Index 649-020 Steel CCTV Pole

COMMENTARY

These proposed changes were developed based on implementing a maintenance service slab for ITS cabinets recommended during the TDH integration into statewide criteria. Language has also been added to Specification 676 for the maintenance service slab.

649-020 1 of 6

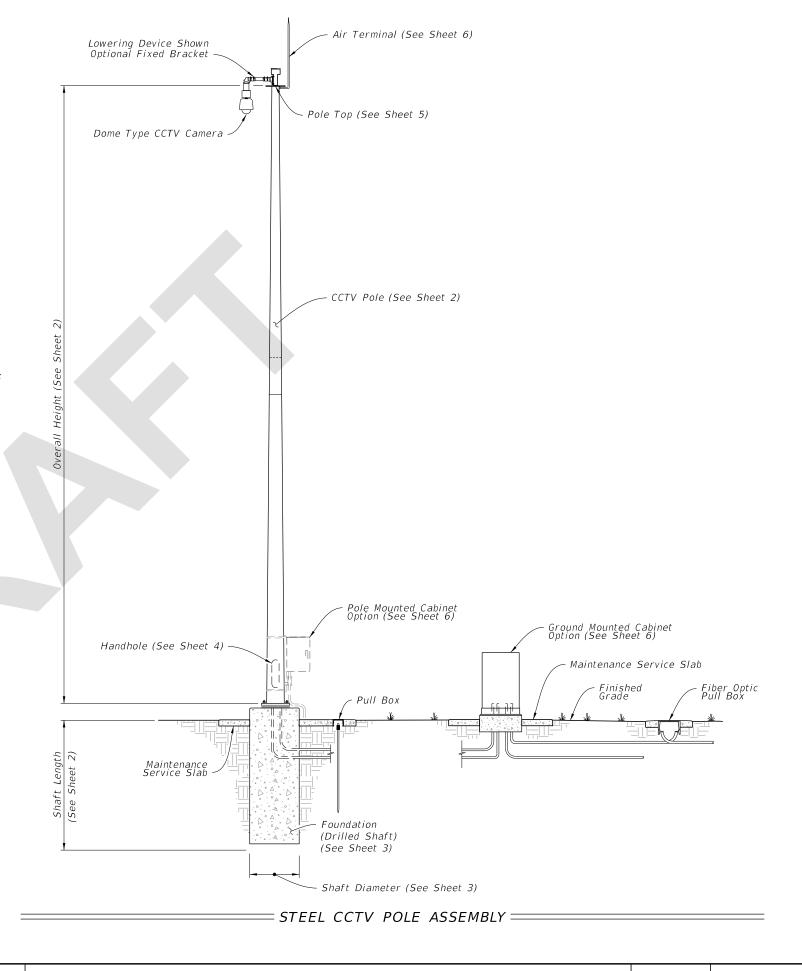
COMMENT: On sheet 6 of 6, maybe the location of the proposed maintenance slab can be shown to be cast against the shaft as opposed to being cast against the conduits. Also, will the Department consider making the maintenance slab of a standard thickness or will it need to be designed by a structural engineer.

RESPONSE: Agree the slab should be shown to be cast against the shaft and the conduits should be adjusted. The maintenance slab is intended to be 6" thick. This is shown in Index 676-010 but will be clarified. We will revise 641-020, 649-020 and 676-010 to show the slab thicknesses accurately.

CHANGE TO THE INDEX: Edit slab adjacent to shaft and adjust conduit. Edit pull boxes throughout the index to show 6" aprons to match maintenance service slabs.
